**SUBJECT: Response to Request For Additional Information Concerning the 2003 Steam Generator Inservice Inspection Reports**

### Response to Request For Additional Information Concerning the 2003 Steam Generator Inservice Inspection Reports

Eggcrate and Tube Support Plate Intersection –  
Bottom View with Maximum Stress and Crack Locations

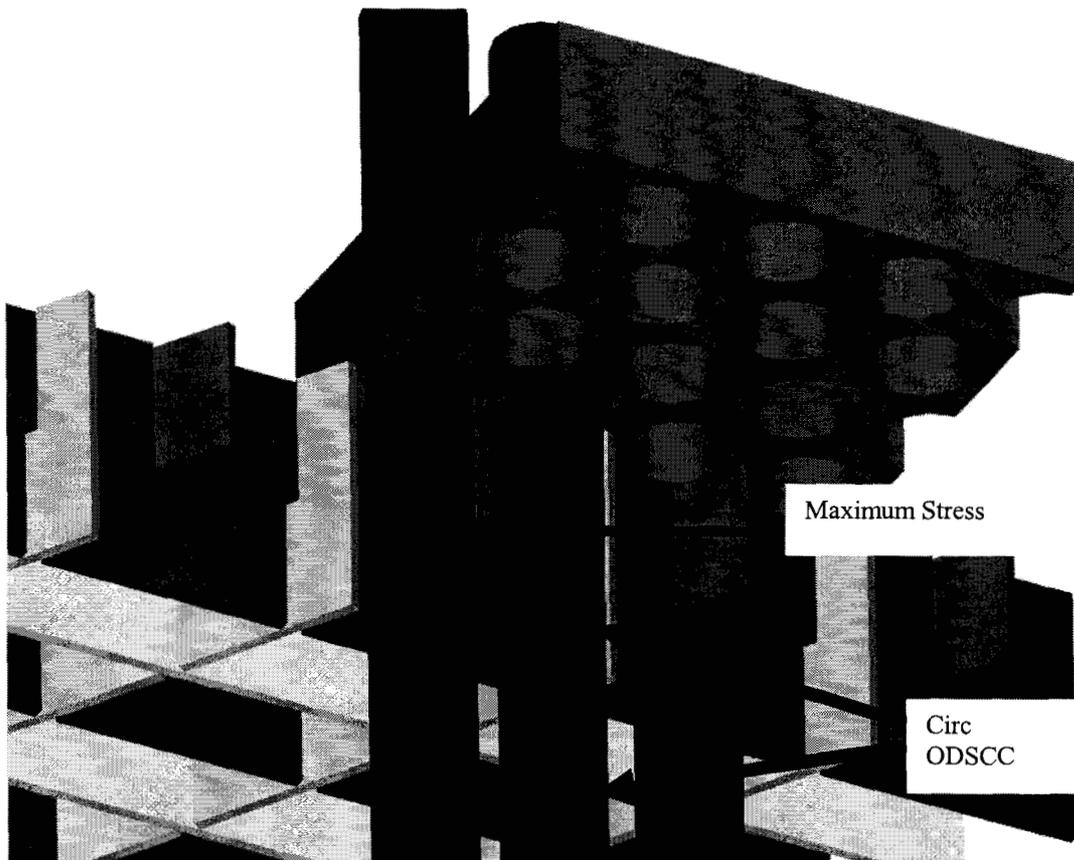
In steam generator B, a single circumferential indication (SCI) was located at the seventh eggcrate support and four SCIs were located in the freespan (areas not encompassed by a support structure). Please discuss any unique circumstances, including dents, associated with these indications and discuss the implications for future susceptibility of the eggcrate supports and freespan region to circumferentially oriented degradation.

A root cause analysis was conducted after the inspection. The indication identified at the eggcrate support is at the chord region (edge) of the partial drilled support plate (see UT results for SG B Row 84 Line 73 listed above in question #1). A second tube (also in the chord region) with a circumferential indication at an eggcrate location was detected in SG B (R87/L52) at support H4 – 1.10". This support structure is also a combination eggcrate / drilled plate assembly. The indication is 0.27 volts with an estimated depth of 33% and an arc length of 21 degrees. The three coil delta probe confirms the presence and orientation of the flaw. The low frequency pancake coil data shows that the flaw is located below the tube support plate and the azimuthal orientation of the flaw is about 120 degrees relative to the eggcrate lattice. Only one lattice bar is evident in the ECT data. This intersection was not included in those tested by UT.

At the top of these eggcrates along the chord the edge of the drilled plate is scalloped and has the shape of a series of semi circles when viewed from the top. Growth of the drilled plate from denting results in a bending strain at and below the eggcrate where the tube is restrained from movement in the lateral plane. This configuration is unique to the chord region and these locations have been identified as a critical area in accordance with EPRI guidelines. The February 2005 examination will include plus point coil testing of 100% of this critical area.
